Nippon Garment Industries Ltd.

93, Auchpara, Tongi, Gazipur - 1712
(23.915849N, 90.393507E)

25th February 2015

Observations

**Female Toilets
1st floor**

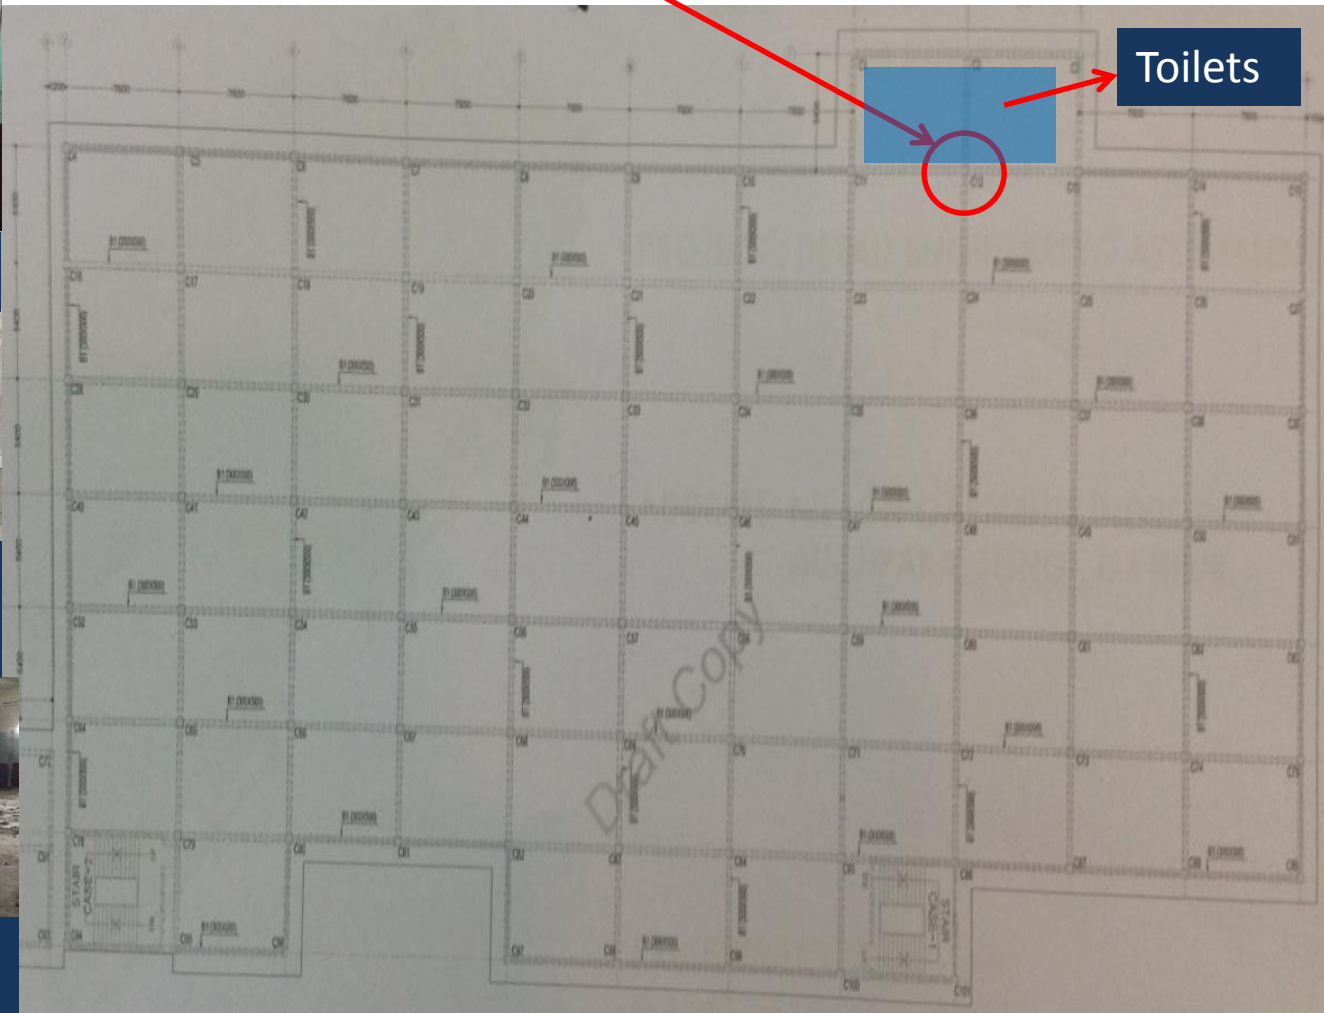
**High stress level in column around toilet
on Ground Floor from floor build up in
toilets at first and second floor.**

Cursory calculations indicate column (marked with red circle) at the Ground Floor is highly stressed under their current loading condition.

Item No.	Observation	Recommended Action Plan	Recommended Timeline
1	High stress level in all columns, in particular to columns around toilet on Ground Floor (grid lines J1, K1, L1, J2, K2 & L2). Core results indicate low concrete strengths	A Detail Engineering Assessment to be commenced on building 1, see attached Scope.	Immediate - Now
2	High stress level in all columns, in particular to columns around toilet on Ground Floor (grid lines J1, K1, L1, J2, K2 & L2). Core results indicate low concrete strengths	Building Engineer to review concrete strengths and as built reinforcement to columns supporting toilet area to assess column capacity and if necessary reduce floor loads (by removing toilet raised platform) in this area.	Immediate - Now
3	High stress level in all columns, in particular to columns around toilet on Ground Floor (grid lines J1, K1, L1, J2, K2 & L2). Core results indicate low concrete strengths	Detail Engineering Assessment to be completed on building 1.	6-weeks

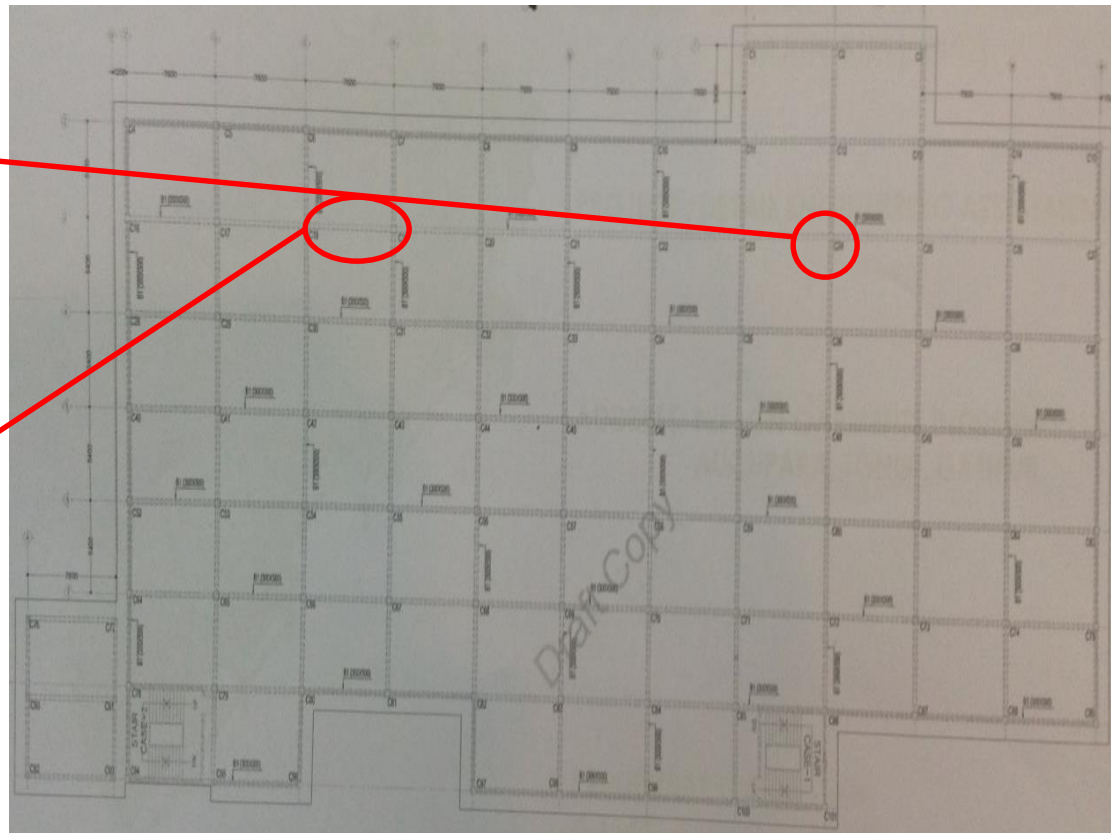
Cracking on beams and columns

Cracking on column at second floor

Cracking on beam at first floor

Item No.	Observation	Recommended Action Plan	Recommended Timeline
6	Cracking on beams and columns	As part of the DEA noted in Item 1 the Building engineer is to investigate the cracking in the beams	6-weeks
7	Cracking on beams and columns	Building Engineer to expose surface of the concrete beam in a number of locations to determine if the cracking extends through the finish into the beam. Also beams repaired with epoxy to be checked in case of reoccured cracks and make recommendations for remedial measures if required.	6-weeks
8	Cracking on beams and columns	Carry out remedial work if required.	6-weeks
9	Cracking on beams and columns	Make structural alterations as advised by Factory Engineer.	6-months
10	Discrepancy between information on drawings and site observations	As part of the Detail Engineering Assessment (see Item 1), Factory Engineer to update the engineering drawings (especially for number of rebars in columns).	6-weeks

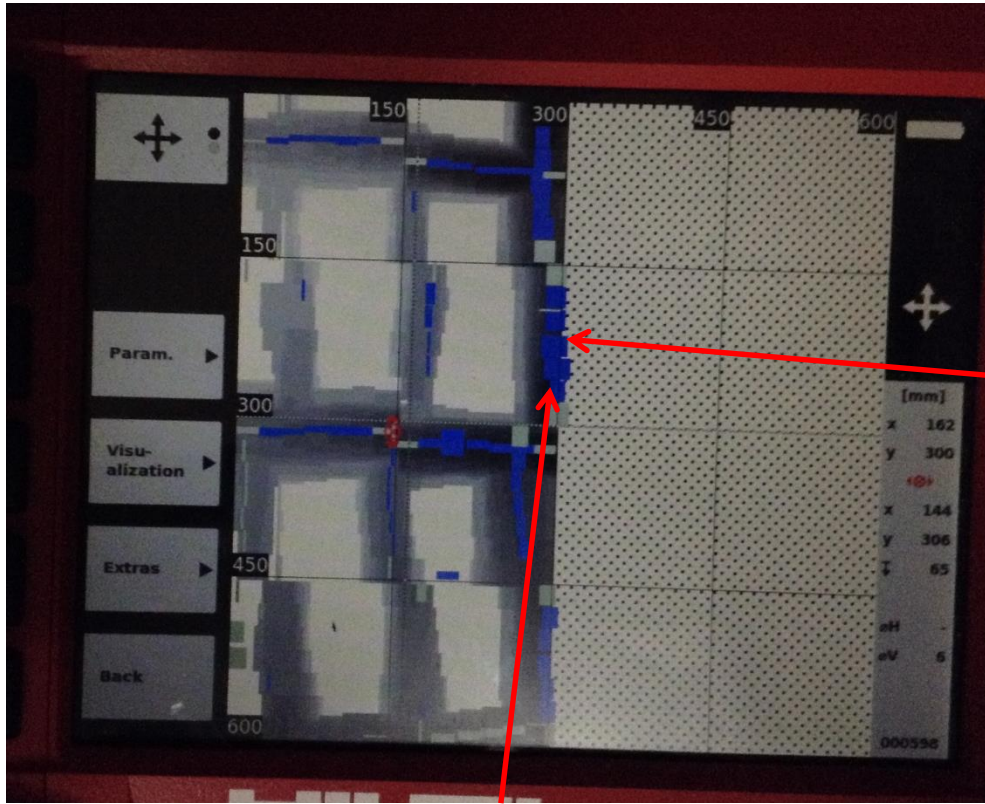
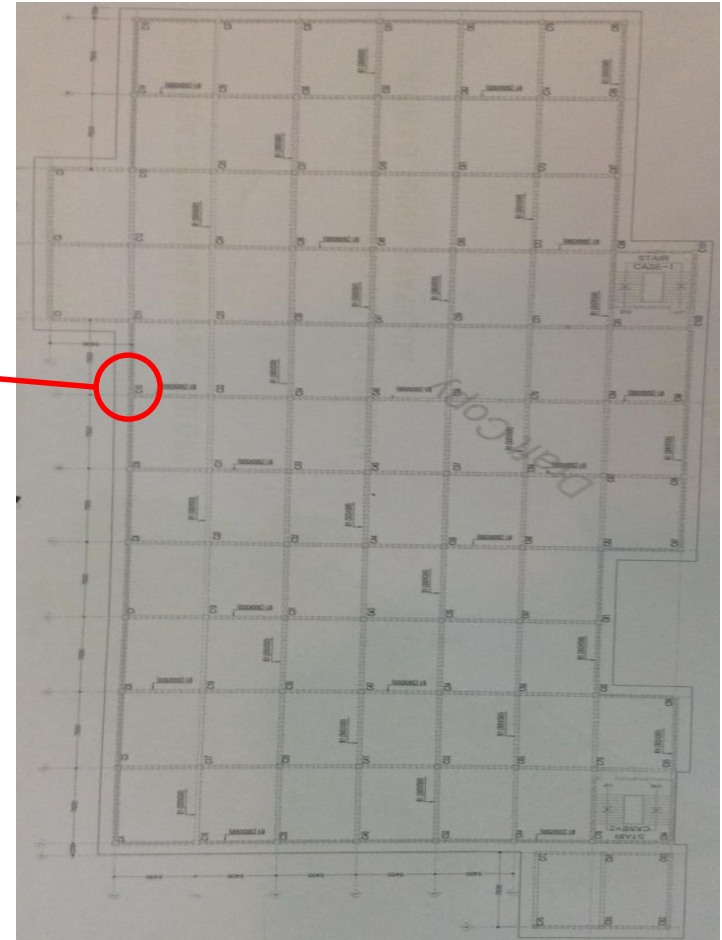
Discrepancy between information on drawings and site observations

Ferroscan indicated 3 bars in each face (i.e. 8 bars in total). Drawings indicate 12 bars

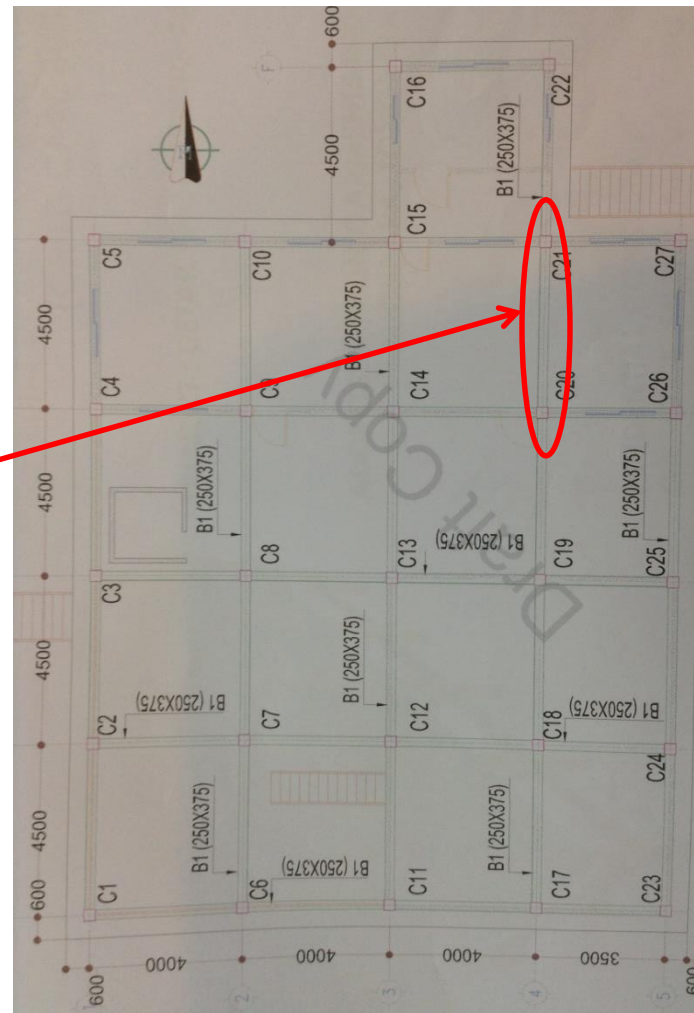
Cracking on beam

Significant cracking on beam at first floor

Item No.	Observation	Recommended Action Plan	Recommended Timeline
12	Cracking to beam	Building engineer to make recommendations for remedial measures if required.	6-weeks
13	Cracking to beam	Carry out remedial work if required.	6-weeks
14	Cracking to beam	Make structural alterations as advised by Factory Engineer.	6-months
15	Uncovered water tank	Building Engineer to review concrete strengths and as built reinforcement to columns supporting the water tank to assess column capacity and if necessary reduce column loads by demolishing the tank or the columns need to be strengthened if the tank is required for future use.	6-weeks
16	Uncovered water tank	Or clearly mark on tank that it is not to be filled and cover to prevent rain water filling (consider making hole in tank at base so water can not collect in tank)	6-weeks
17	Discrepancies between information on drawings and site observations	Factory Engineer to update the engineering drawings (especially for number of rebars in columns).	6-weeks

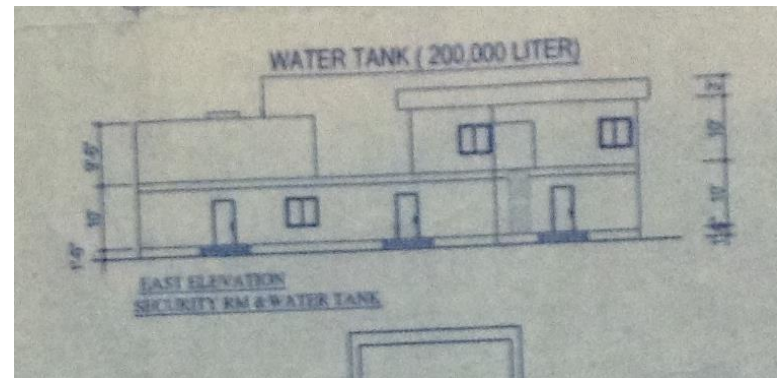
**Uncovered water tank (Not in Use).
High stress level in columns under tank, if
tank is filled in the future**

Cursory calculations indicate that columns below tank would be over stressed if tank gets filled with water.

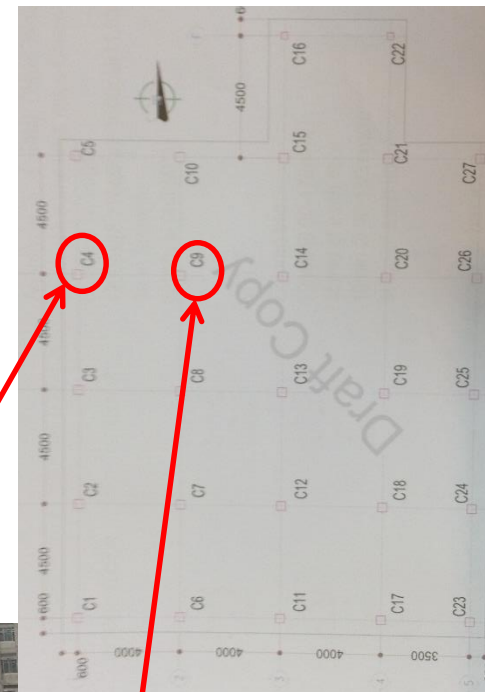
Only 6 rebars were observed on site. Drawings show 10 bars.

Column dimensions were measured as 300mmX300mm excl. plaster

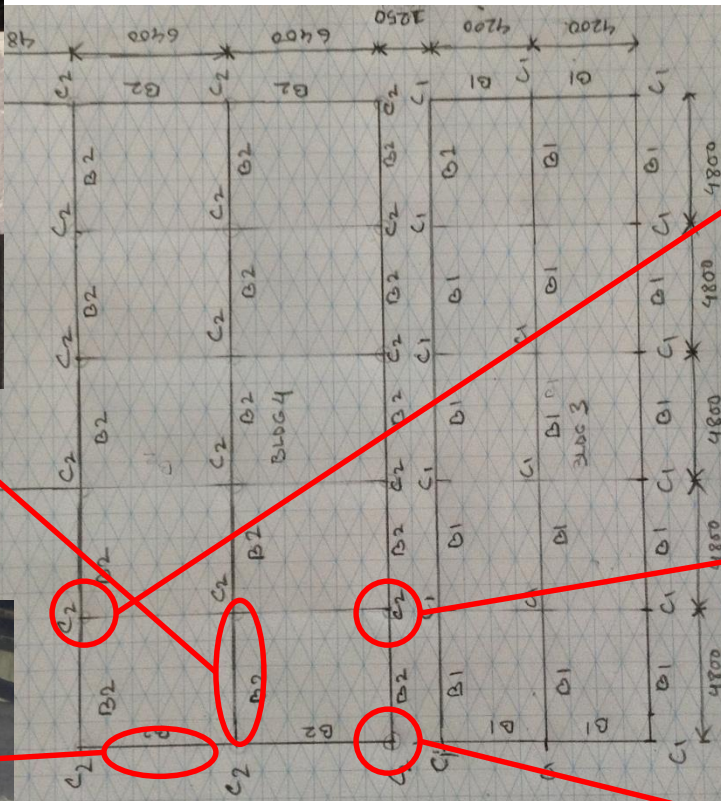
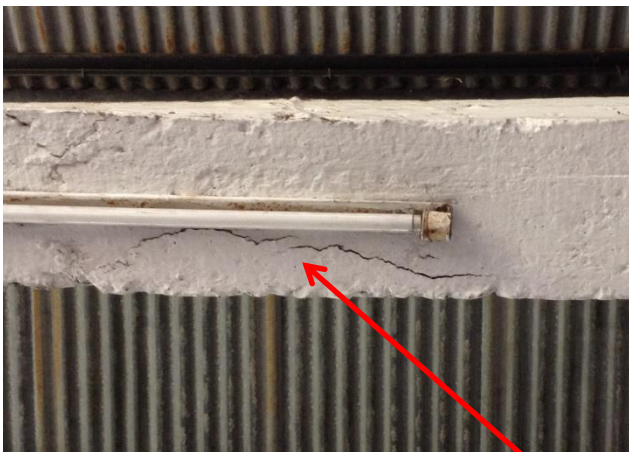
Cracking on columns and beams

Significant cracking on number of columns and beams (likely due to corrosion of reinforcement)

Item No.	Observation	Recommended Action Plan	Recommended Timeline
22	Cracking on columns and beams	Building engineer to investigate cause of cracking in columns and make recommendations for remedial measures.	6-weeks
23	Cracking on columns and beams	Make structural alterations as advised by Factory Engineer.	6-months
24	Apparently non-engineered structures	Building engineer to check the capacity of the lightweight roofs and make any necessary alterations.	6-months
